# PECOS DISTRICT DRILLING CONDITIONS OF APPROVAL

OPERATOR'S NAME: Devon Energy Production Company, L.P.

WELL NAME & NO.: | Gaucho Unit 33H

# PECOS DISTRICT SURFACE USE CONDITIONS OF APPROVAL

Figure 1. Cross-sections and plans for typical road sections representative of BLM resource or FS local and higher-class roads.

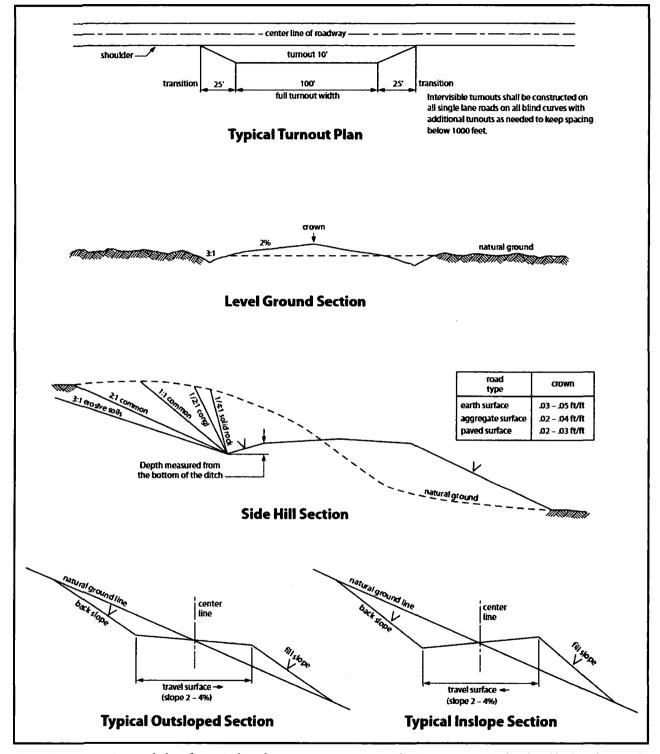
Crowning shall be done on the access road driving surface. The road crown shall have a grade of approximately 2% (i.e., a 1" crown on a 14' wide road). The road shall conform to Figure 1; cross section and plans for typical road construction.

Vehicle turnouts shall be constructed on the road. Turnouts shall be intervisible with interval spacing distance less than 1000 feet. Turnouts shall conform to Figure 1; cross section and plans for typical road construction.
